Access Compliance Report

Public Rights-of-Way

Intersection ID: 52452	Main Street: PAT_GARRETT_ST	Cross Street: BENDING_BIRCH_PL	Location: SW
ADA ID: 712DAD308E45	Ramp Type: Directional1	Initial Pass/Fail: Pass	Overall Compliance: No
Severity Score: 15			
Codes/Mitigation Info/Possible Solution		Field Measurements/Component Compliance

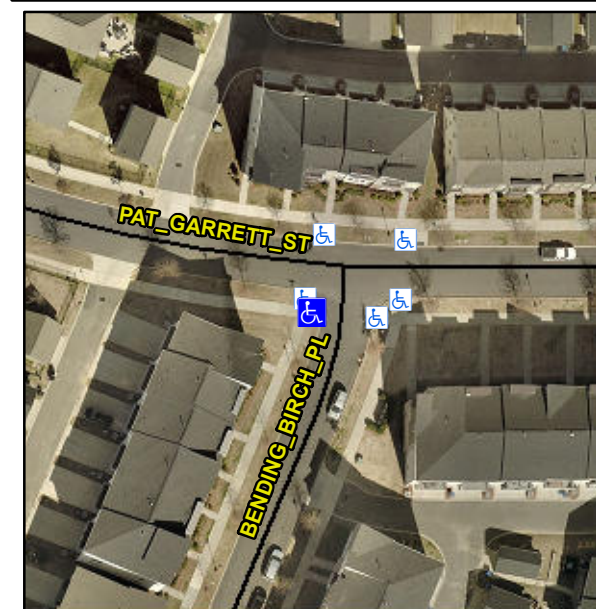
DAMAGED GTR

R302.7.2

Grind Gutter Lip.
